VALUE ENGINEERING STUDY

Project # STP00-1004-00(002) PI No. 631260-

EXTENSION OF SR 382 FROM CR 239 TO SR 5/515 Gilmer County, Georgia

17 November 2011

PROPOSAL NUMBER: PV-2.1

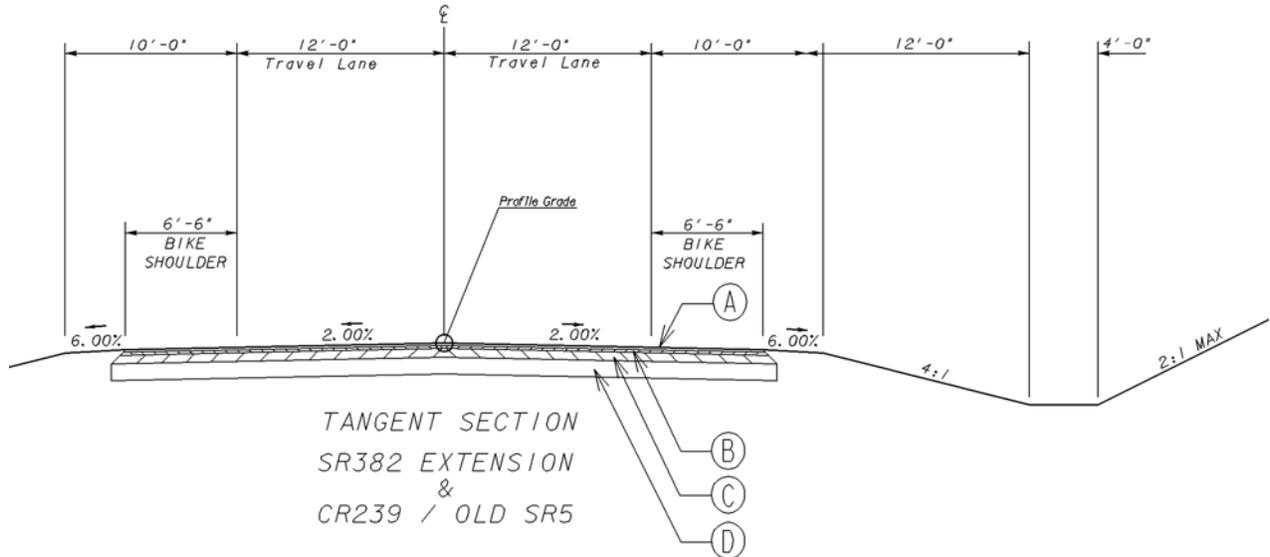
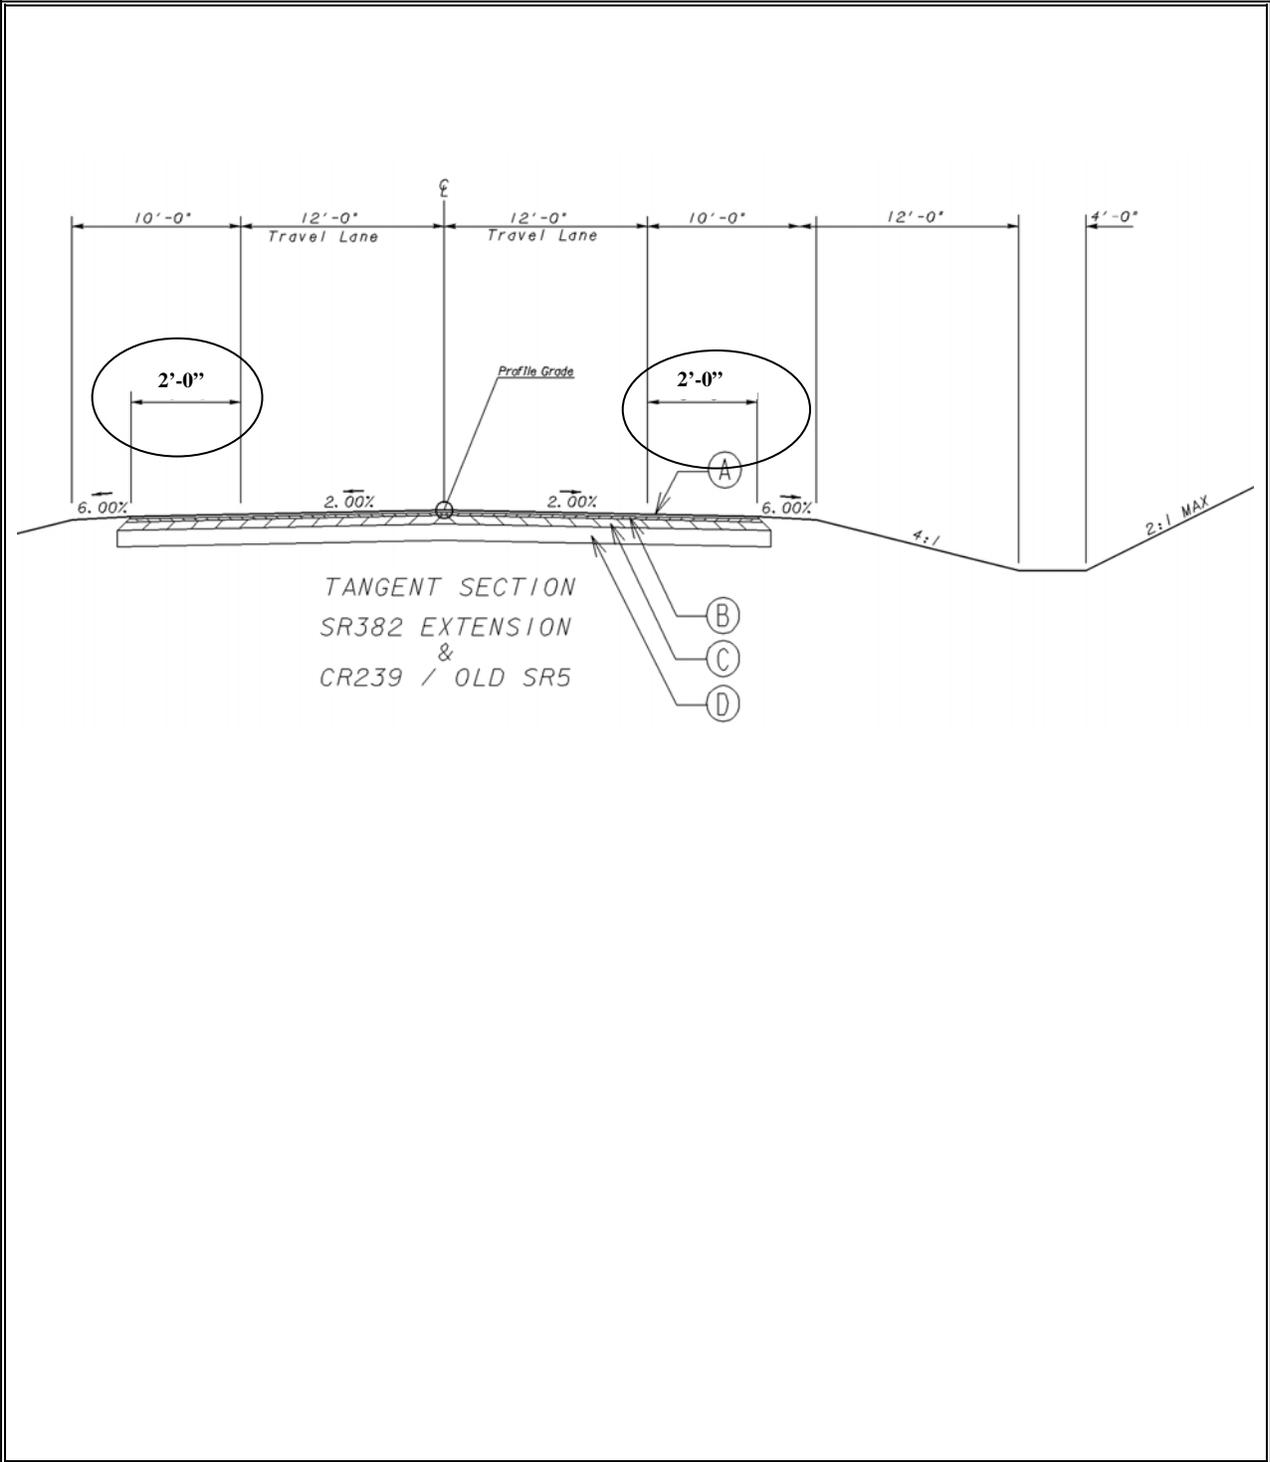
PROPOSED CHANGE: The proposed change proposes to install a 2 foot wide paved shoulder on the SR 382 extension and CR 239, and eliminate the 4.0 foot width for bike traffic. This is not an approved/designated bike route.

PROPOSAL NUMBER: PV-4.0

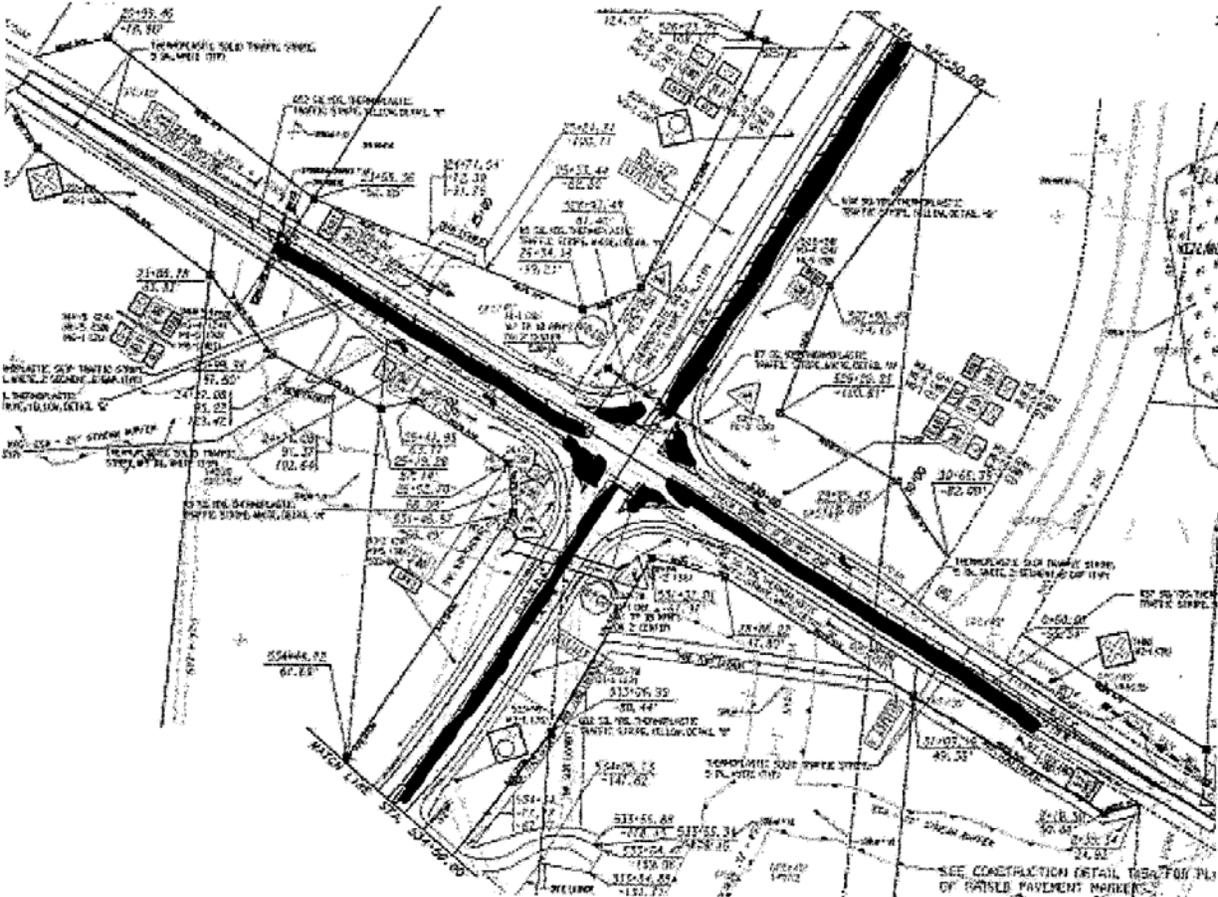
PROPOSED CHANGE: The proposed recommendation is to reduce the lane width, bike lanes, and striping at the new intersection.

PROPOSAL NUMBER: PV-6.0

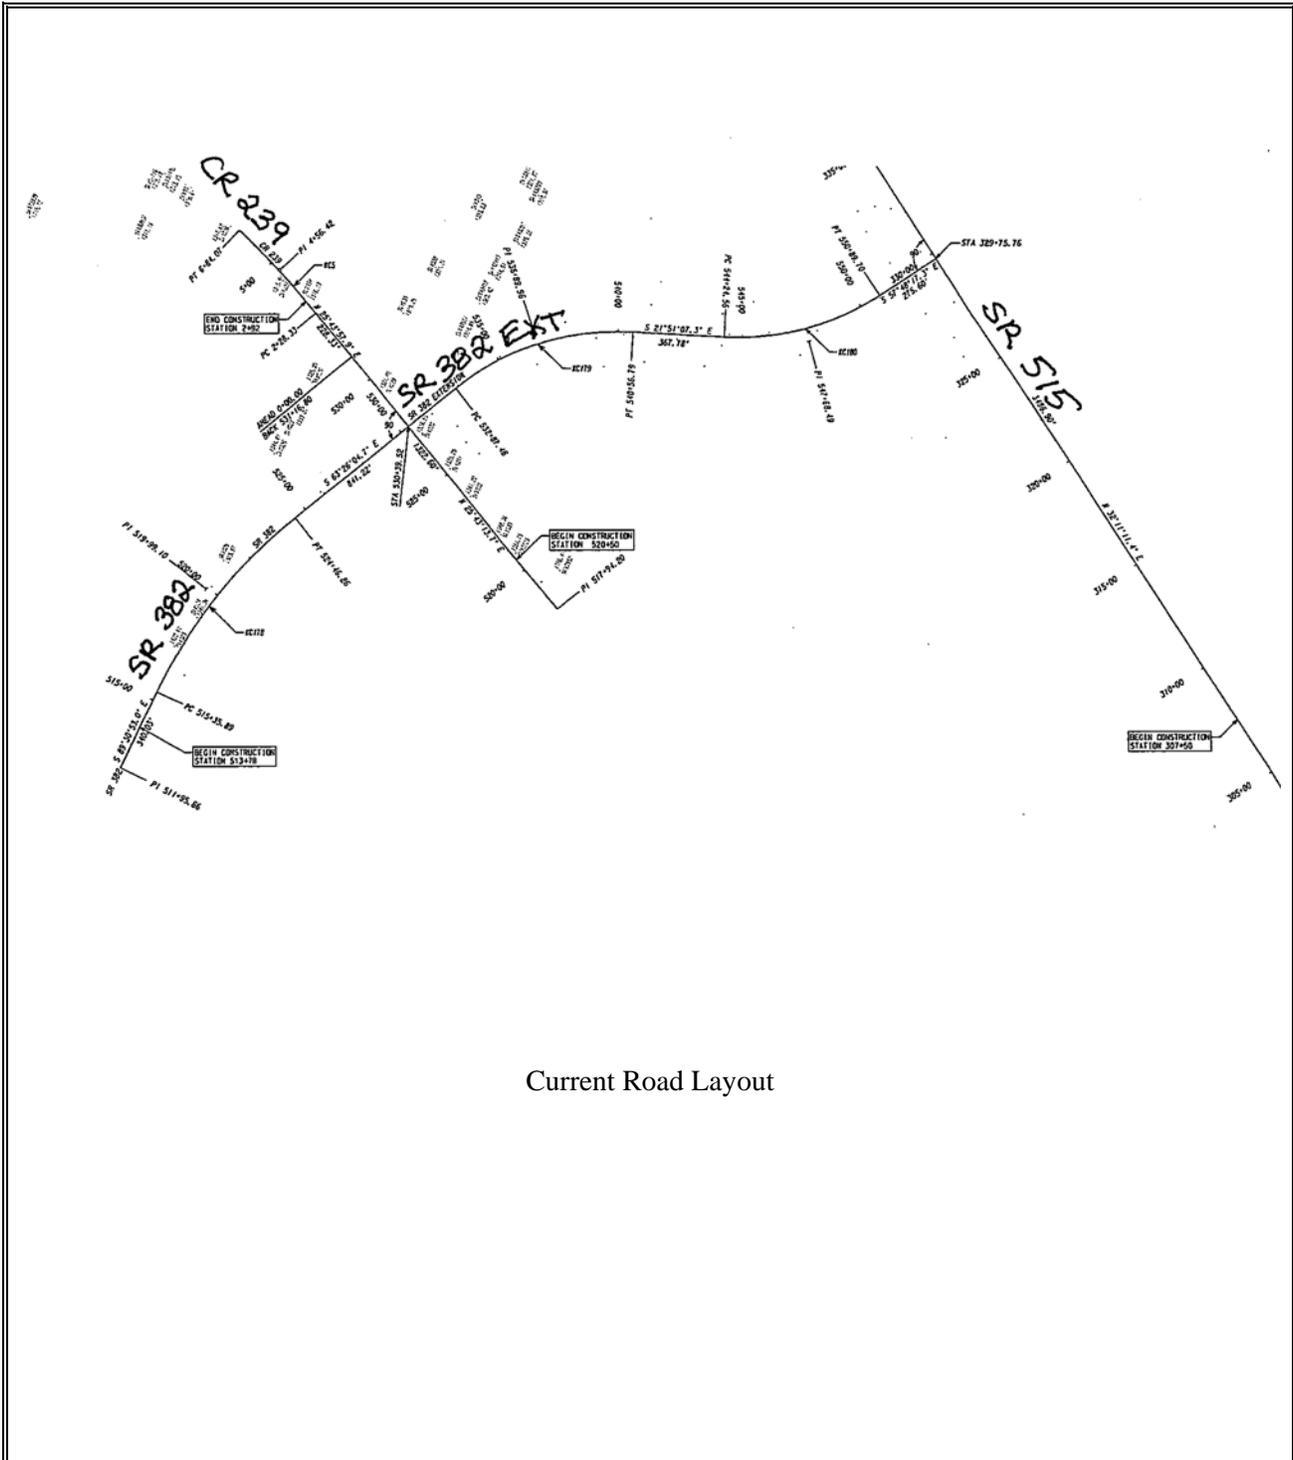
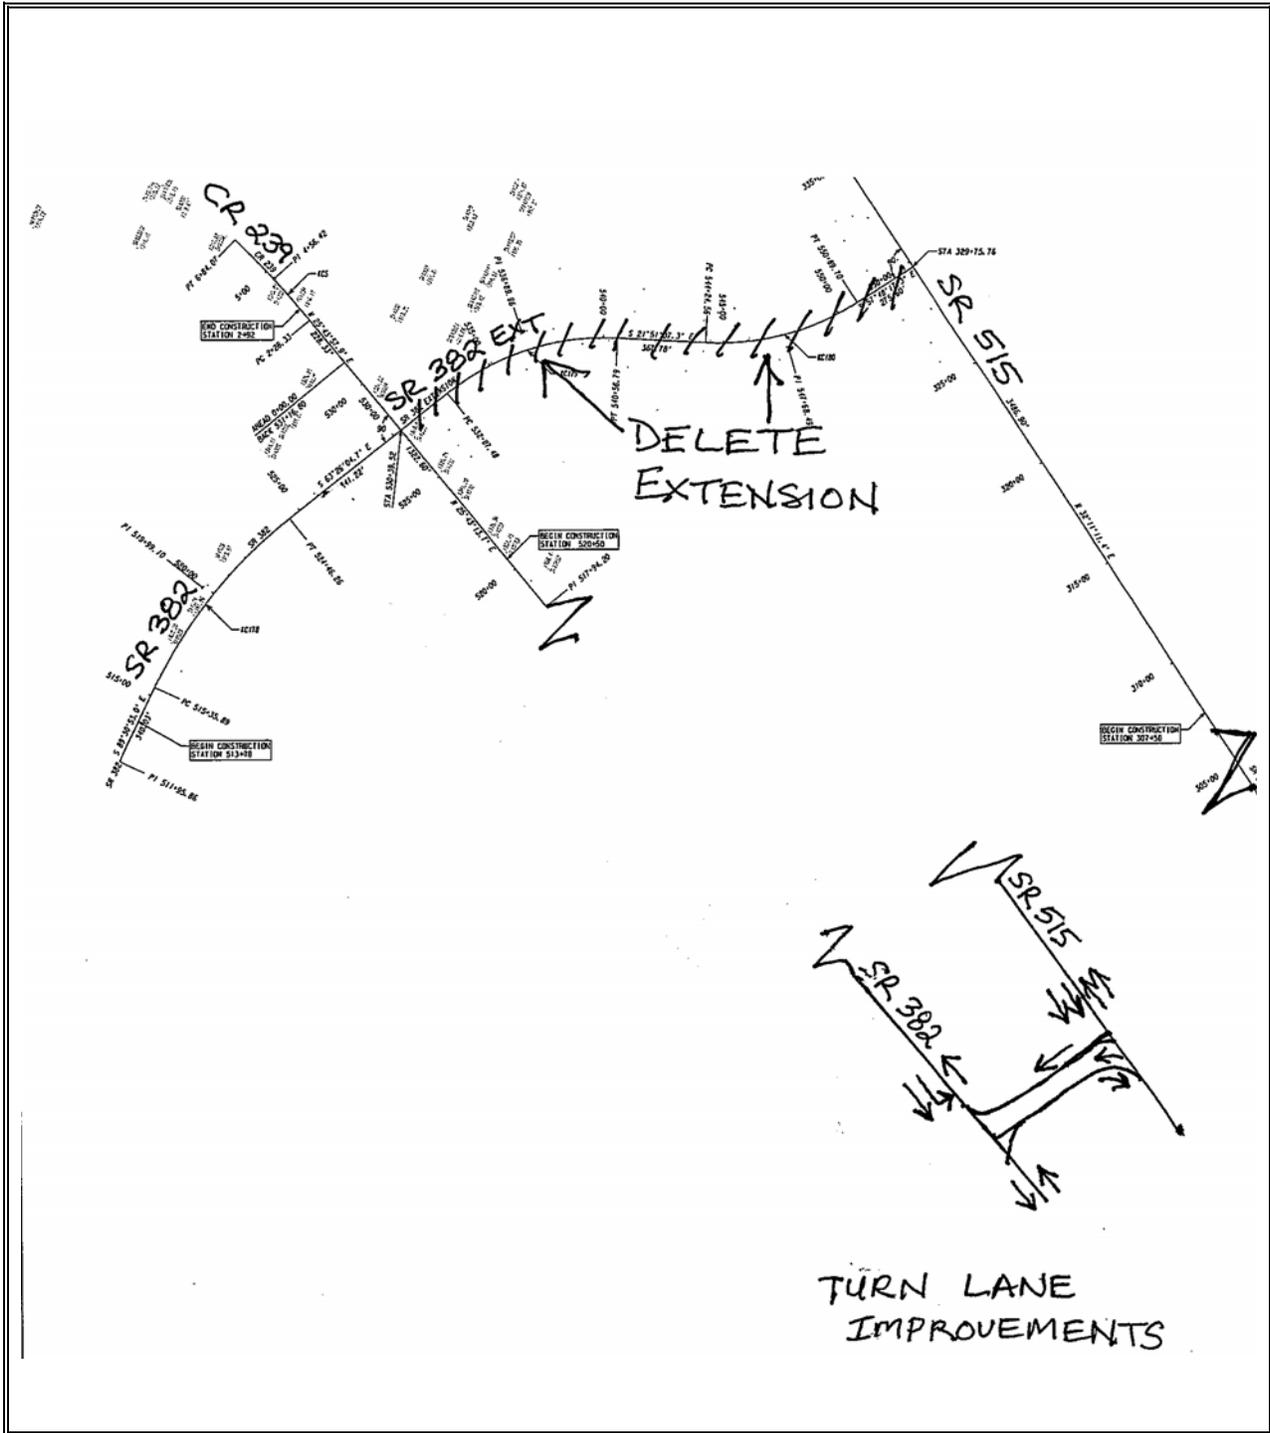
PROPOSAL DESCRIPTION: ELIMINATE THE EXTENSION OF SR 382 TO SR 515 (MAJOR SCOPE CHANGE) BY MAKING IMPROVEMENTS TO SR 382 AND SR 515 APPROXIMATELY 1.5 MILES TO THE SOUTH.

PROPOSED CHANGE: The proposed recommendation is to eliminate this extension and replace movement with turn lane improvements further south on SR 382 (approximately 1.5 mile) at existing SR 515 intersection.

PROPOSAL NUMBER: PV-6.1

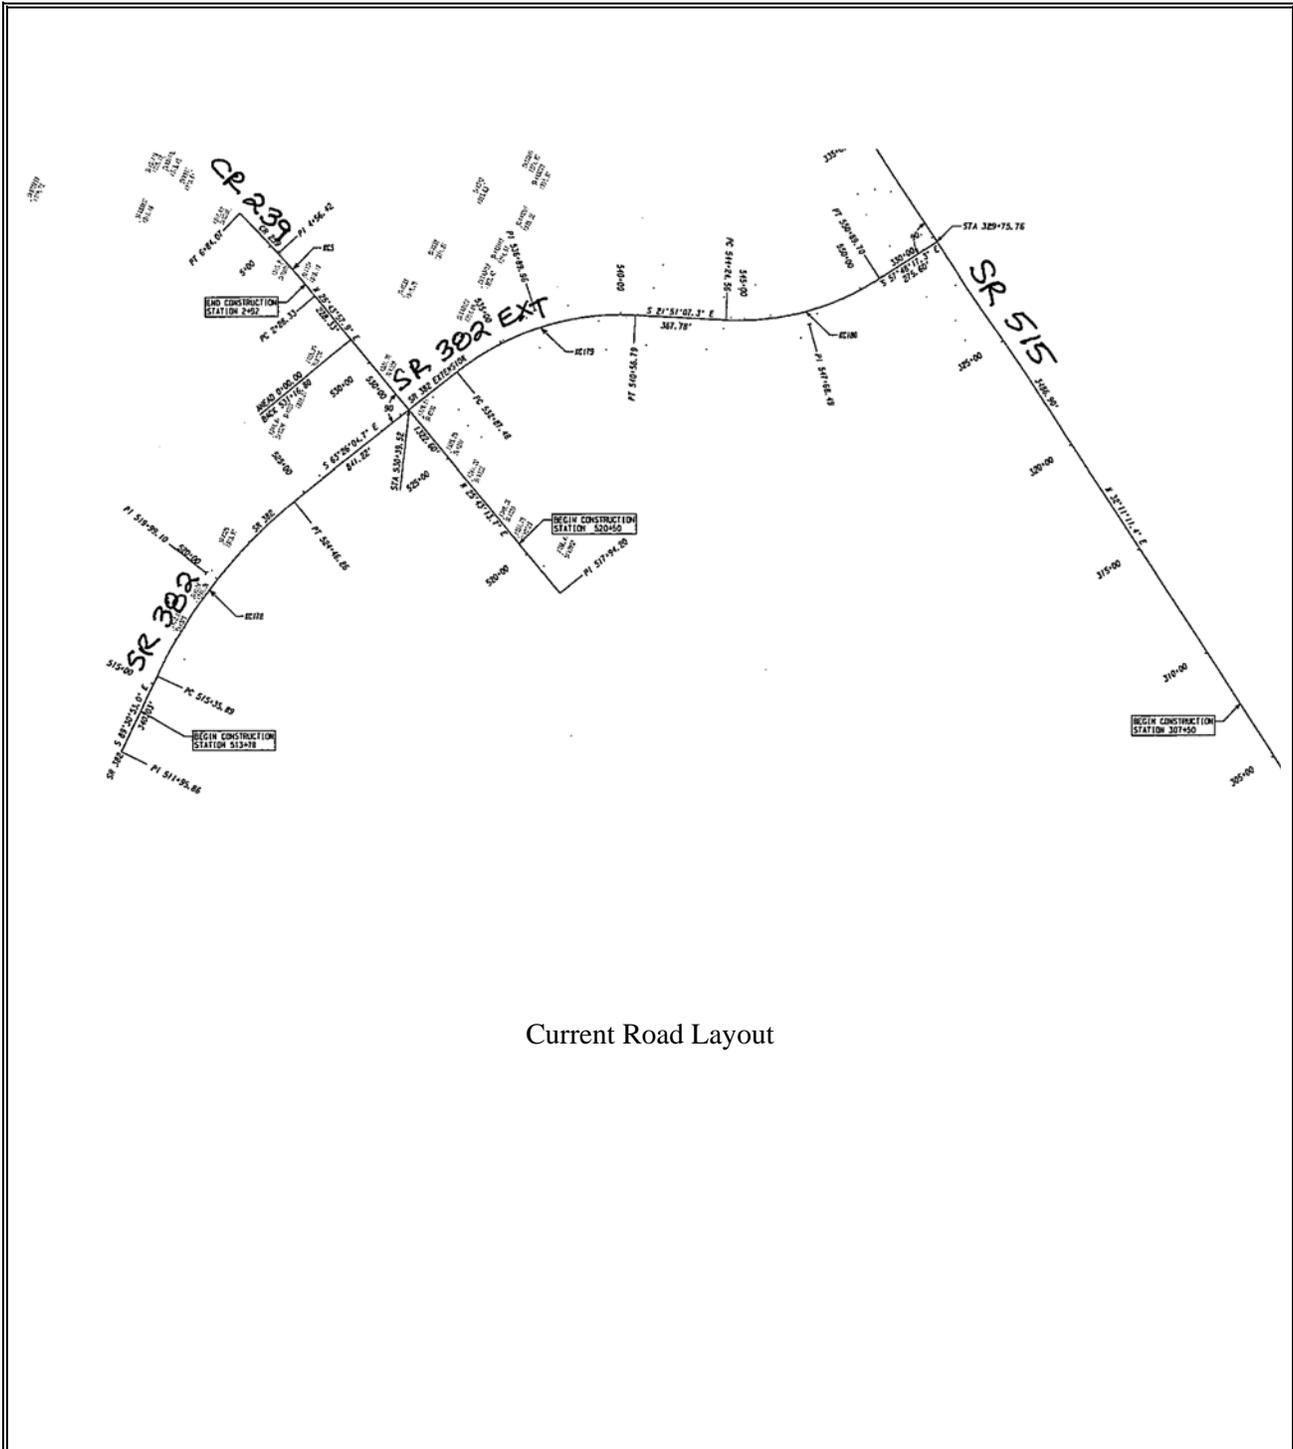
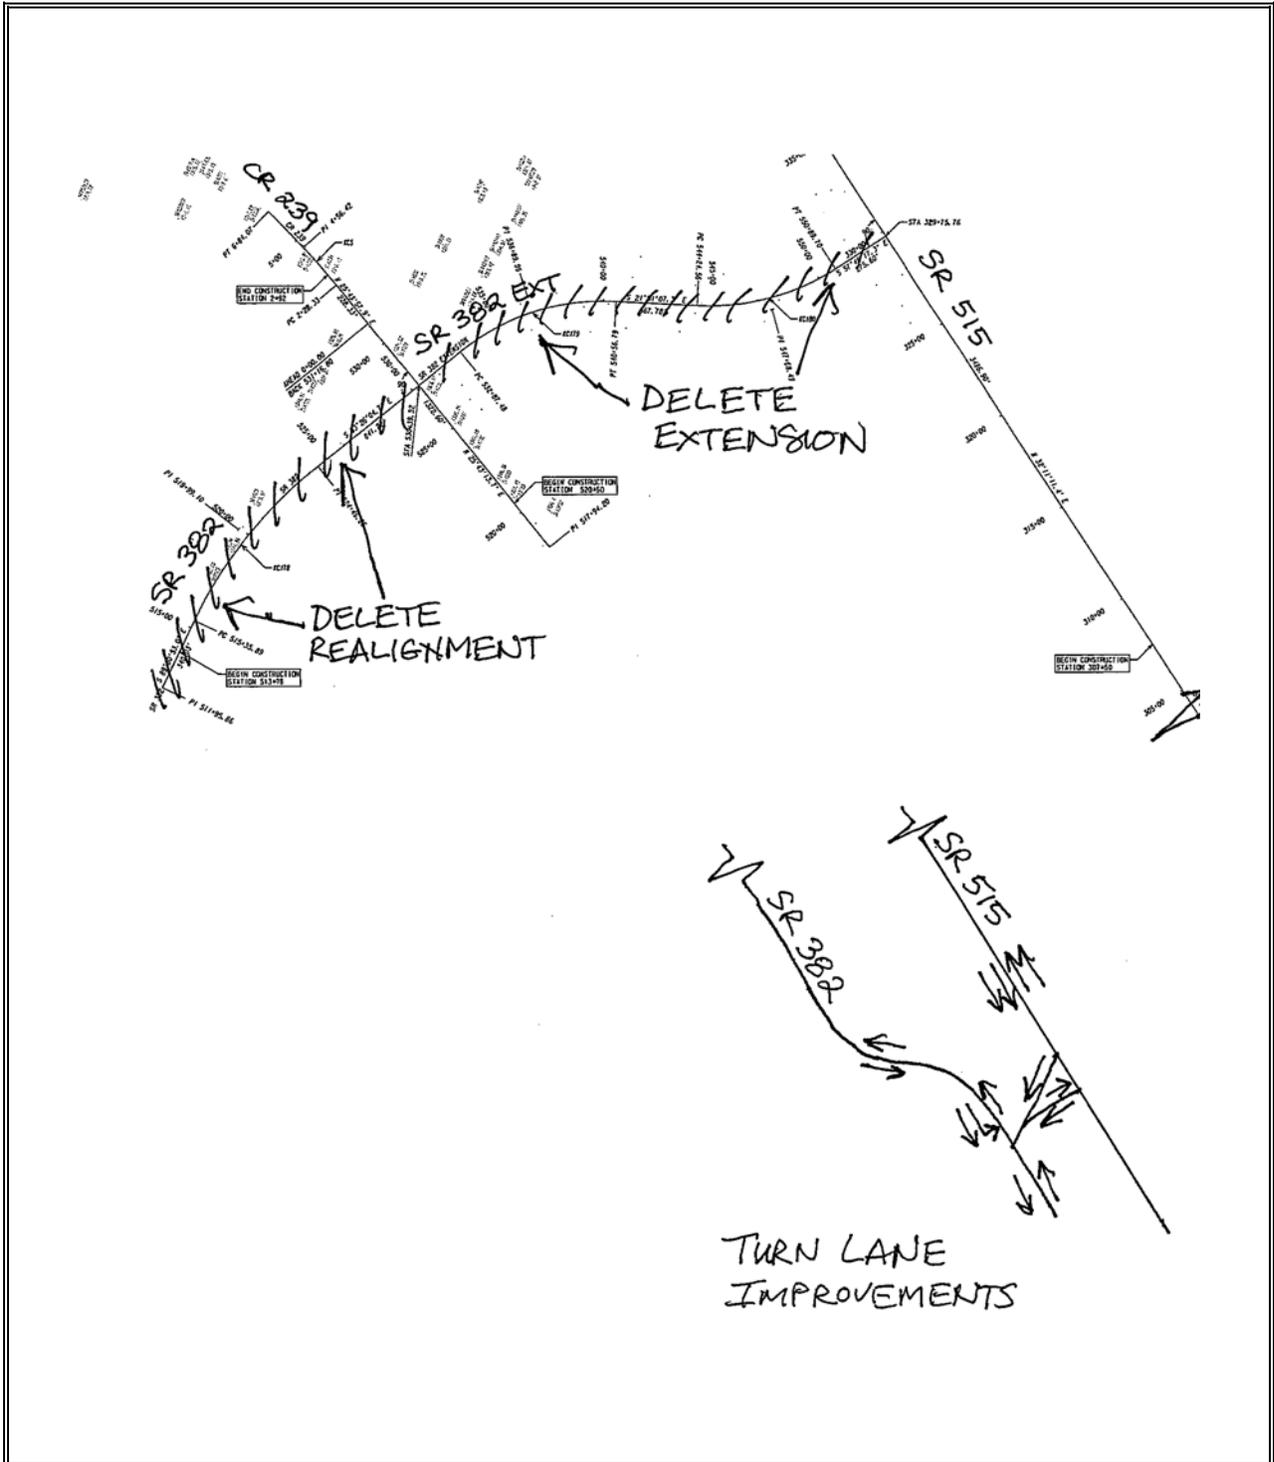
PROPOSAL DESCRIPTION: ELIMINATE THE RELOCATION AND EXTENSION OF SR 382 TO SR 515 (MAJOR SCOPE CHANGE) BY MAKING IMPROVEMENTS TO SR 382 AND SR 515 APPROXIMATELY 1.5 MILES TO THE SOUTH.

PROPOSED CHANGE: The proposed recommendation is to eliminate the relocation and replace movement with turn lane improvements further south on SR 382 at existing SR 515 intersection.
